**Basement Impact
Assessment Audit**

30 Grove Place, London NW3
1JR

Project No.
14006-89

Date
March 2025

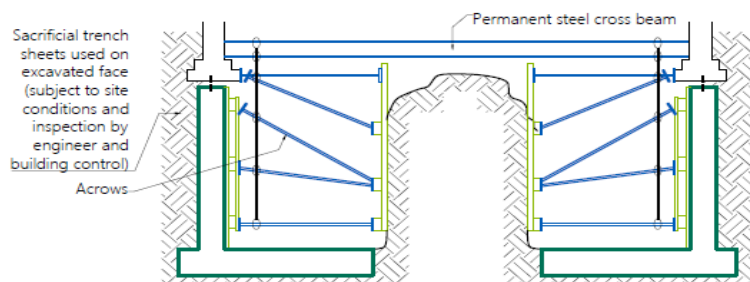
The ground movement assessment applies the long-term and short-term heave movements against the vertical movement to determine the maximum deflection. The report states this is due to it being assumed that 'the soil mass is removed in its entirety before the underpins are placed'. This is not considered to be a conservative assumption as the underpins will need to be installed before the basement can be excavated. In addition, as stated in the D1 report, heave movements will likely be confined to the basement perimeter and will not extend beyond the retaining wall. The assessment should therefore consider the potential damage for the underpin installation where no excavation has been undertaken.

In general the reason why we consider this assessment conservative is that there is a transition between short term movements and long-term movements. If hypothetically all the soil is removed below the basement in an instant there would be unrestrained heave across all of the basement excavation. However, in practice there is some excavation, some reloading from the underpins as the hit and miss sequence is undertaken and the central soil mass is only removed once the underpins have been installed. This limits the unrestrained short-term heave on the basement walls. So the model is likely to overestimate the heave and is therefore conservative. Heave from excavation is the main issue, as we have already determined the settlement is low due to the low net bearing pressure being less than the undrained shear strength of the formation soil.

The underpin installation is part of the basement excavation. You have to excavate the soil in order to install the underpins as shown from Croft drawing TW03 included in the MGC BIA report, but it is accepted this is carried out as a first stage.

This may result some heave, before the underpins are installed on a hit and miss basis, although this will be mostly cancelled out from the foundation loads. This stage of the installation has now been specifically analysed for ground movement.

The central soil mass has also been specifically analysed for ground moment as a second stage. These ground movements have been combined to provide an overall ground movement model. I have included ground movement profiles which will be included in the damage assessment category, which remain well within Category 1.
